Agenda Item	6.6
Report No	PLN/032/25

HIGHLAND COUNCIL

Report Title: 24/04988/FUL: Church of Scotland

Description: Reinstatement of stone cross, installation of double-glazed windows and timber door including internal alterations

Proposed South Elevation

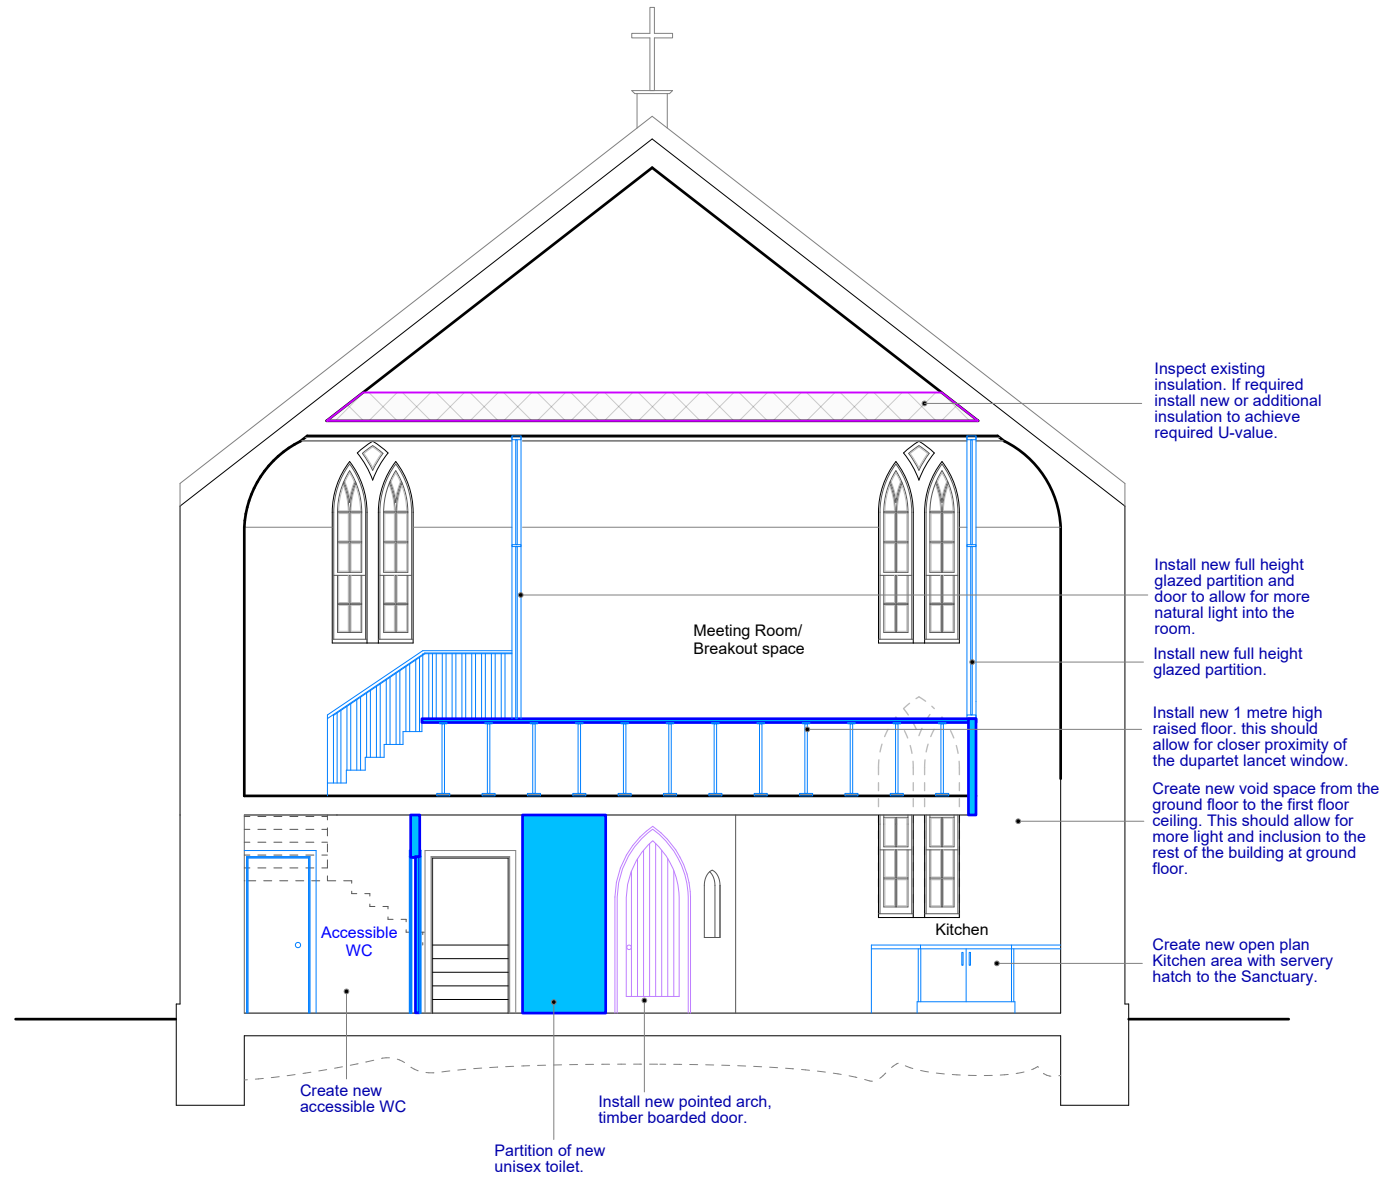
Externally, we are concerned by the enclosure to the heat-pump exceeding the height of the window-cill; why is this necessary? The re-opening and re-instatement of the windows and door to the east elevation is welcomed; details will be required of the new windows (via condition if not available now).

6. For the avoidance of doubt, the air source heat pump detailed on drawing 'PROPOSED ELEVATIONS PLAN -SOUTH – 213' is not approved as part of this listed building consent hereby granted.

- 8.6 Following concerns raised by the Historic Environment Team – Conservation, the installation of an air source heat pump was removed from the proposal, and as such the impact that this may have had on the building is not required to be assessed.

Reason: The air source heat pump has been removed from the proposal.
